UNITED STATES PATENT AND TRADEMARK OFFICE

APPLICATION NO.	FILING DATE	FIRST NAMED INVENTOR	ATTORNEY DOCKET NO.	CONFIRMATION NO.
09/172,553	10/14/1998	JAMES E. GREEN	2914.IUS	9441

Office Action Summary

DETAILED ACTION

Fig. 22

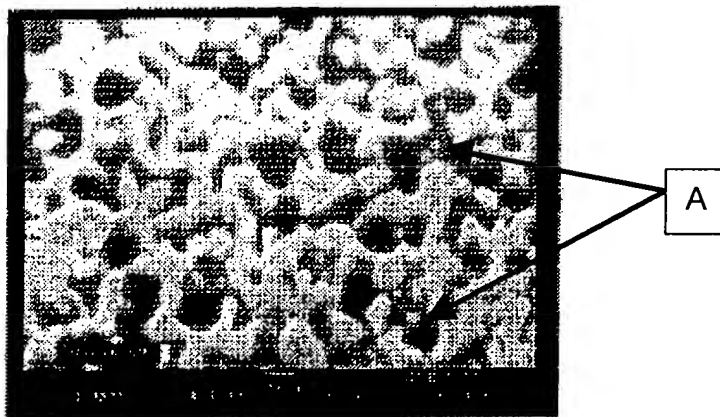
Regarding claims 31-34, the term "contiguous" is confusing. Applicant states in page 6 of the Remarks that "the term "contiguous" refers to structures (1) that touch one another, (2) that share a boundary, or (3) that are connected without a break therebetween." However, such definitions of the term "contiguous", as proposed by Applicant, is improper since at least the proposed definitions 1 and 3 are not supported by the Specification. For instance, Applicant shows in Figure 22 (see below) webs or mesas (A) that are not "contiguous" since they are separated from the other mesas or webs.

**Fig. 21**

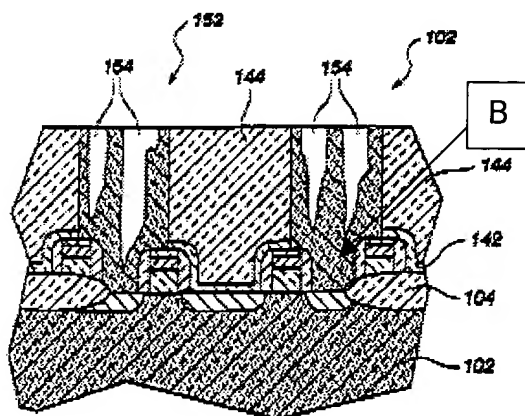
Moreover, Applicant is advised that only the proposed definition 2 apply to describe Applicant's invention since as shown in Figure 21 (see below), the webs or mesas formed between the openings (154) share a boundary (B). Thus, the Examiner would interpret the term "contiguous" as structures that share a boundary.
